## Product Change Notification: BLAS-07ICWM552

CCB 8182 Initial Notice: Qualification of UNIS as a new final test site and scan and pack site for PAC1931T-I/J6CX, PAC1932T-I/J6CX, PAC1933T-I/J6CX, PAC1934T-I/J6CX, PAC1941T-1E/J6CX, PAC1941T-2E/J6CX, PAC1942T-1E/J6CX, PAC1942T-2E/J6CX, PAC1943T-E/J6CX, PAC1944T-E/J6CX, PAC1951T-1E/J6CX, PAC1951T-2E/J6CX, PAC1952T-1E/J6CX, PAC1952T-2E/J6CX, PAC1953T-E/J6CX PAC1954T-E/5SW and PAC1954T-E/J6CX catalog part number(s) available in 16L WLCSP (2.215x2.16x0.7mm) and 16L WLCSP (2.225x2.17mm) package.

**CCB 8182**  
**Pre and Post Change Summary**  
**PCN #: BLAS-07ICWM552**

# Packing Method/Material – Bag - 16L WLCSP (2.225x2.17mm)

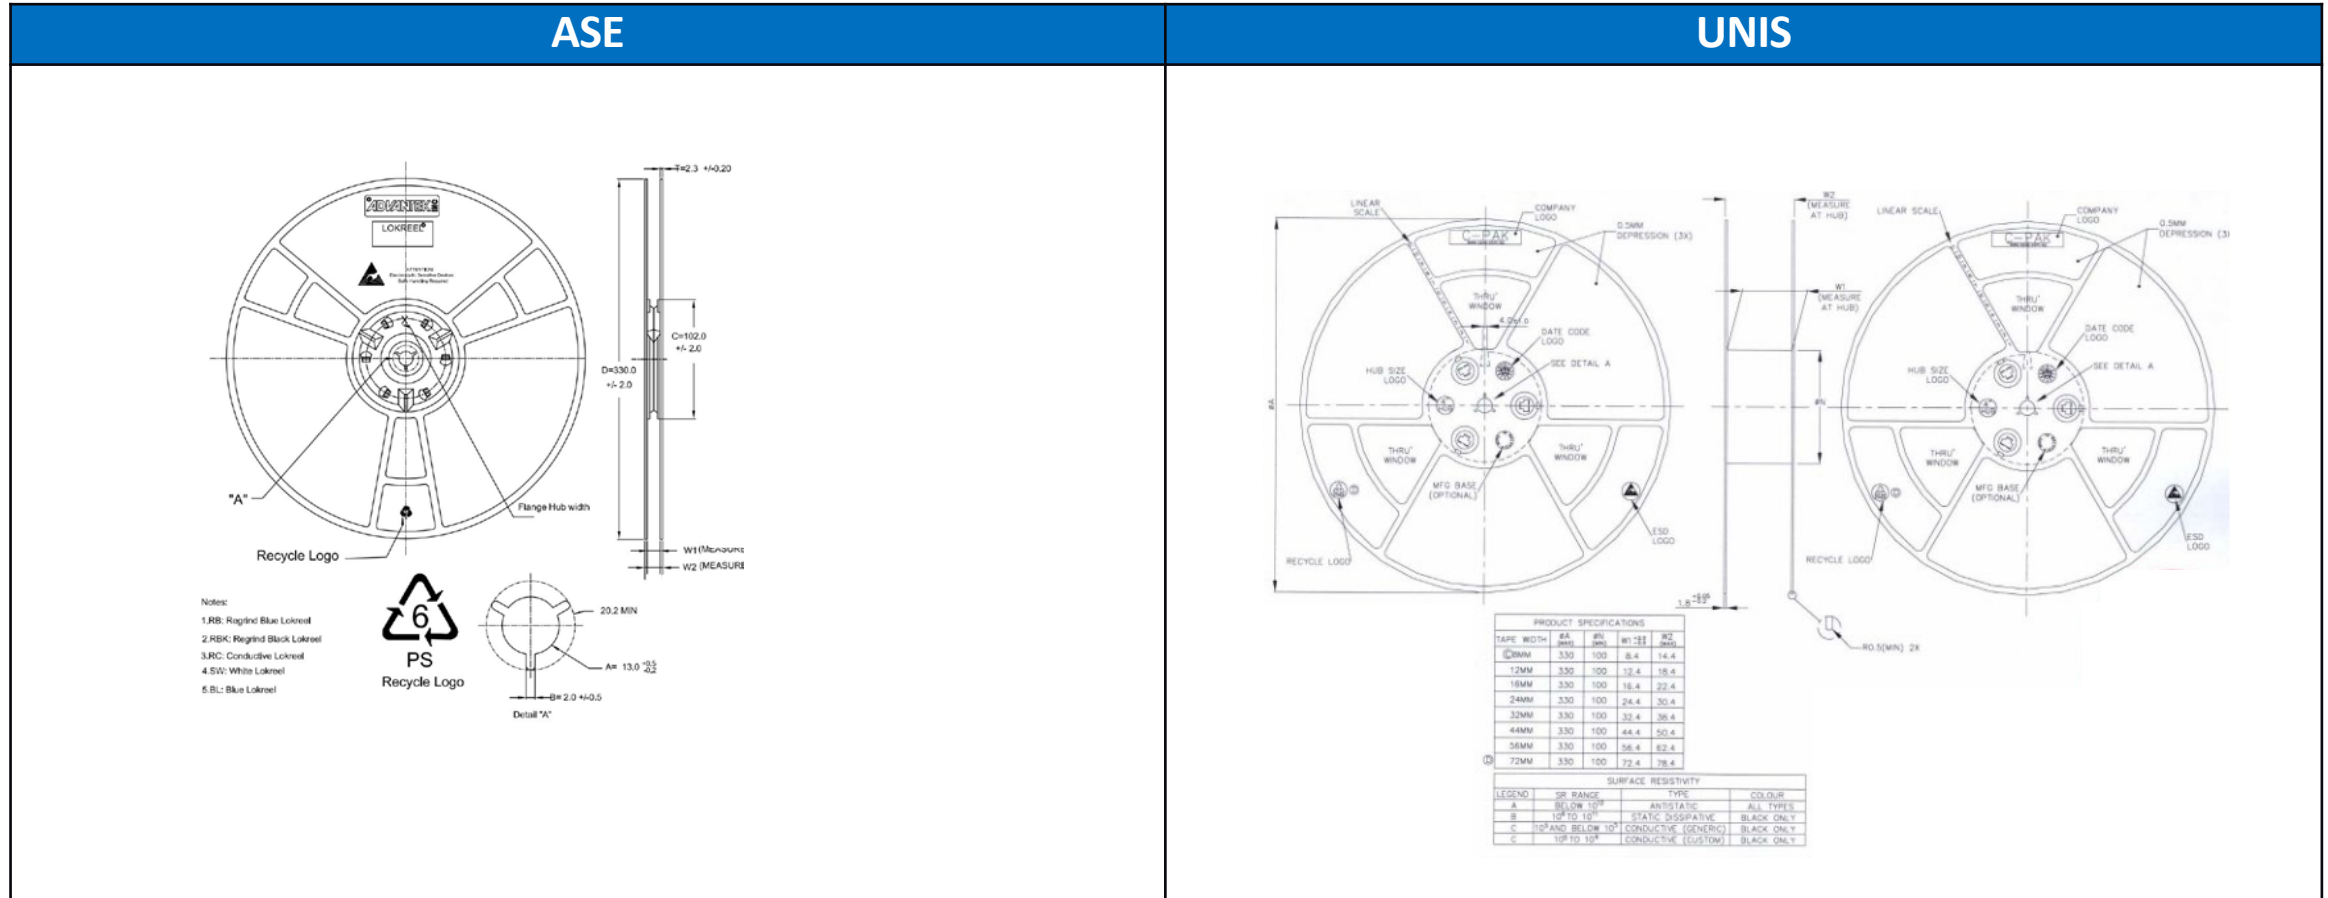
| Plant | Bag type          | Length (mm) | Width (mm) | Thickness (mm) |
| ASE   | Drypack bag       | 450         | 420        | 0.18           |
| UNIS  | Static Shield Bag | 427         | 407        | 0.08           |
